DEVIATION REQUEST AND DECISION FORM

Project Name :	Estates at Cathedral Pines
Schedule No.(s) :	6200000411
Legal Description :	TR IN SE4 SEC 2-12-66 DES AS FOLS: BEG AT SW COR OF SE4 SEC 2, TH N 00<49'17" W 1583.77 FT, N 89<17'56" E 965.20 FT, S 00<49'17" E 1583.77 FT TO A PT ON S LN OF SD SE4, TH S 89<17'56" W 965.20 FT TO POB, TOG WITH INGRESS-EGRESS EASEMENT DES BY REC #200027778

DEVIATION REQUEST (Attach diagrams, figures, and other documentation to clarify request) (Date: 12/18/2023 Initial Submittal) This deviation request is for intersection spacing and a few other geometric/roadway design elements on **Windermere Court**. As such, this deviation includes several itemized parts/elements. Please refer to deviation exhibits 1 – 6b. Deviation Exhibit 1 shows the location of this street on the site plan map.

Deviation Exhibit 1

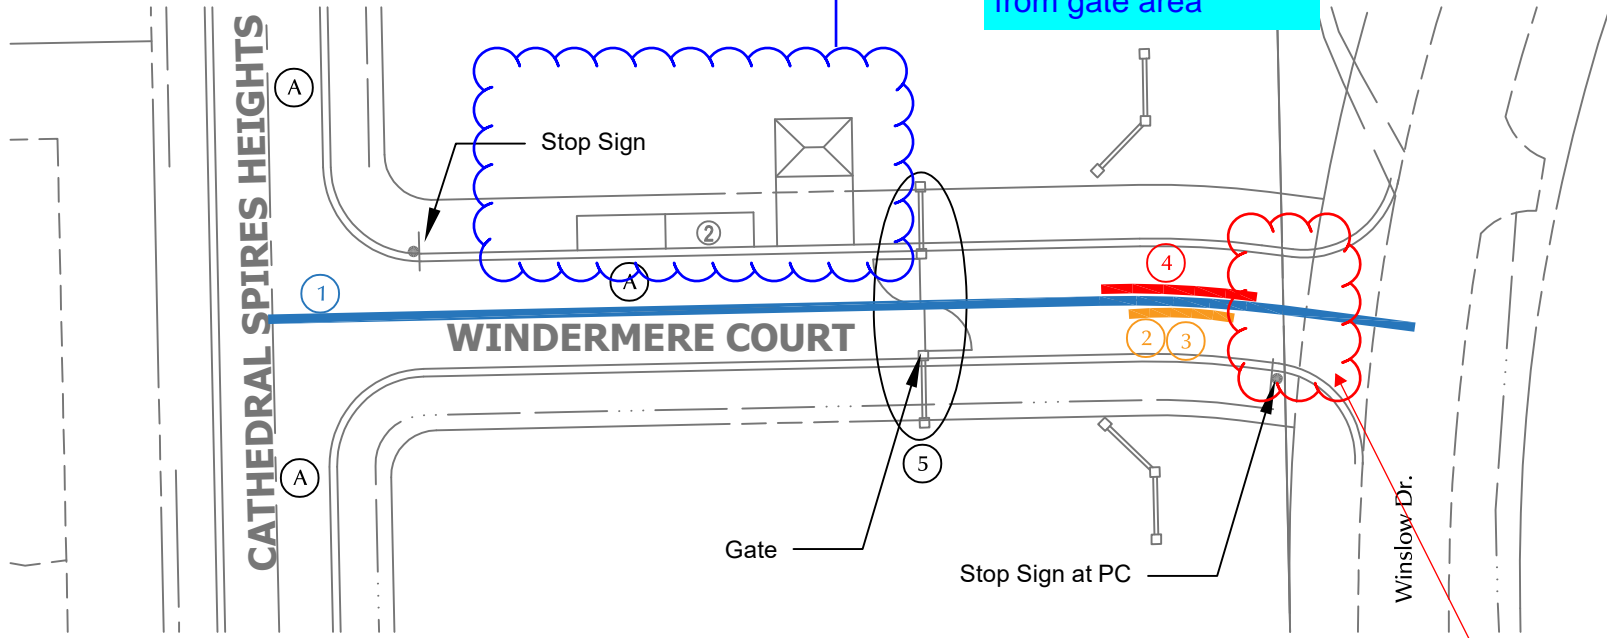
It is recommended to move the mail kiosk and pull off around the corner and away from gate area

Deviation Requests

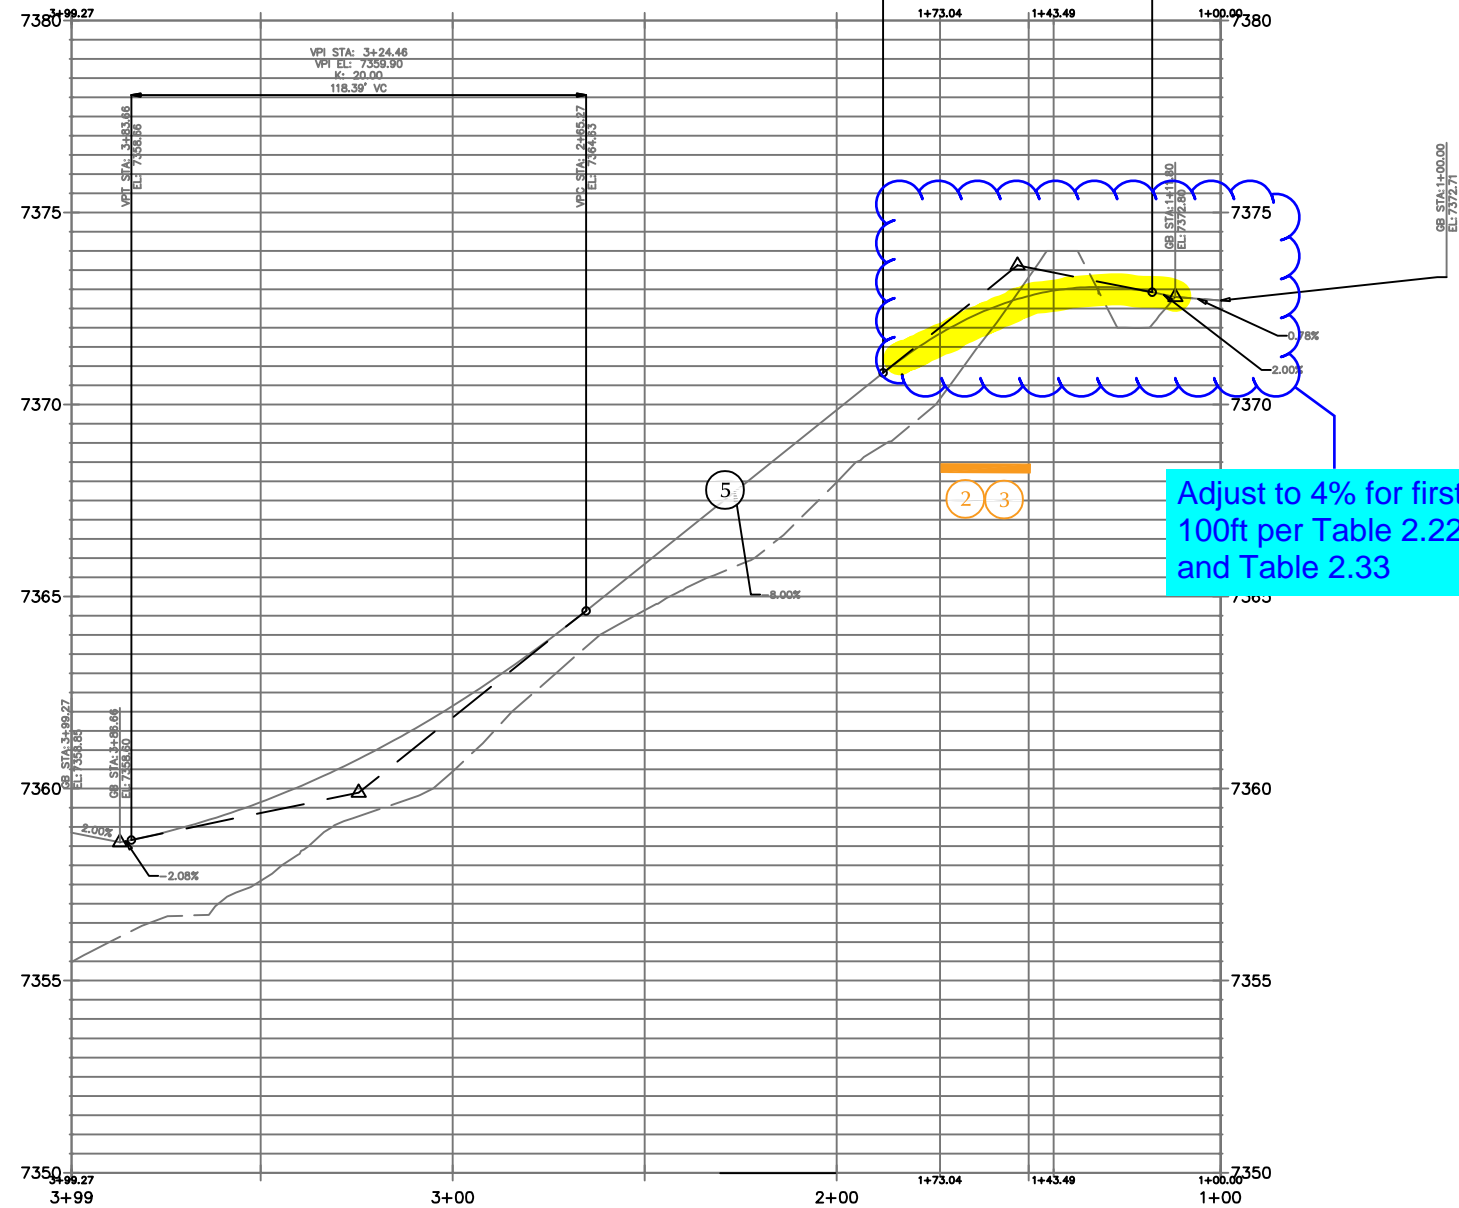
Note that the intersection grade and tangent per Tables 2.22 and Table 2.33 are not met and deviation is not recommended for the first 100ft from Winslow. Update the Deviation and road profile for Windmere Ct (name change TBD) Max 4% for first 100ft

**ACCESS CL PROFILE
STA 1+00.00 TO 3+99.27**

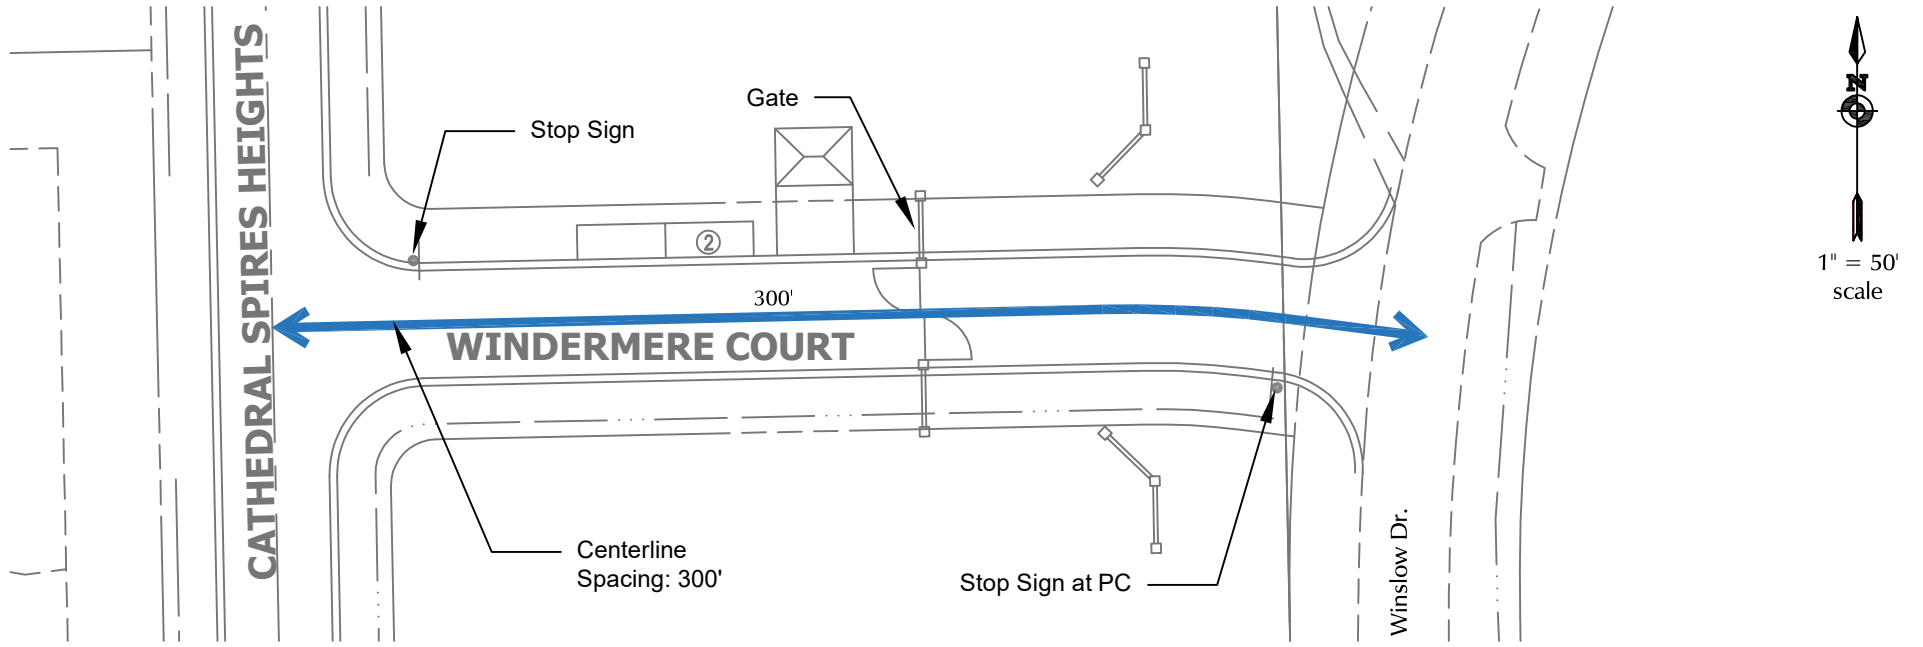
Adjust to 4% for first 100ft per Table 2.22 and Table 2.33
